**RE:** Groundwater Delineation Work Plan  
Spur Energy Partners  
State I #16 Brine Seep  
Incident ID: nAPP2110253617  
Loco Hills, Eddy County, New Mexico  
Terracon Project No. KH237037

Review of the  
Groundwater  
Delineation Work Plan  
for Spur Energy  
Partners, State I #16  
Brine Seep, Incident #  
nAPP2110253617.

Groundwater Delineation Work Plan  
State I #016 Brine Seep | Eddy County, New Mexico  
July 26, 2024 | Terracon Project No. KH237037 | Case No. nAPP2110253617

**EXHIBIT 1**  
**SITE MAP**

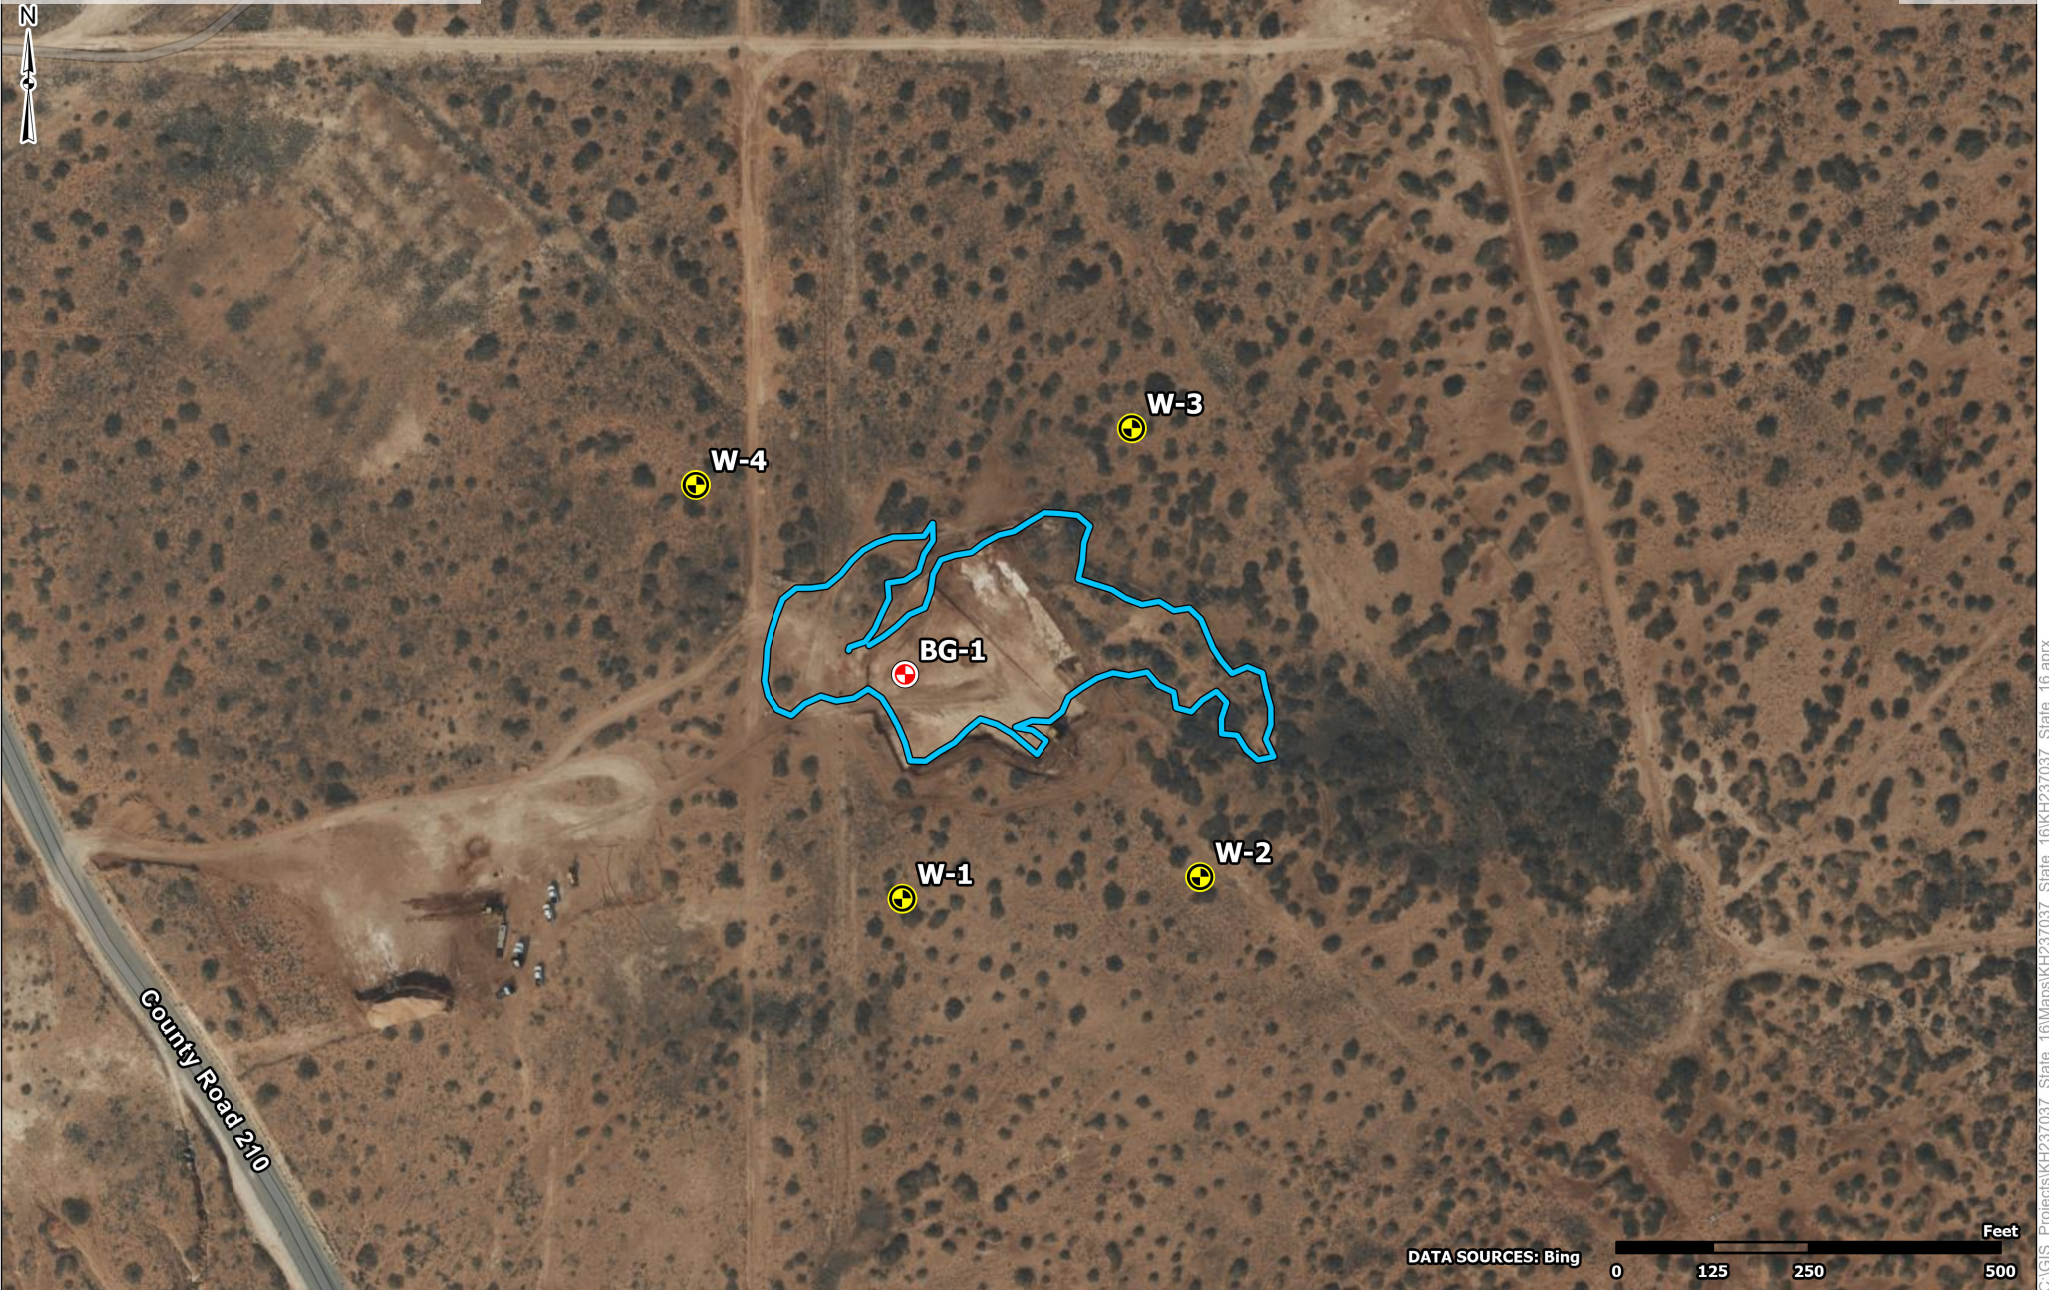
1. Reposition proposed  
W-2 either 20' to 25'  
either southwest or  
northwest away from  
what appears to be a  
pipeline right-of-way.

3. Establish  
groundwater gradient  
direction after  
installation of the four  
(4) proposed wells.
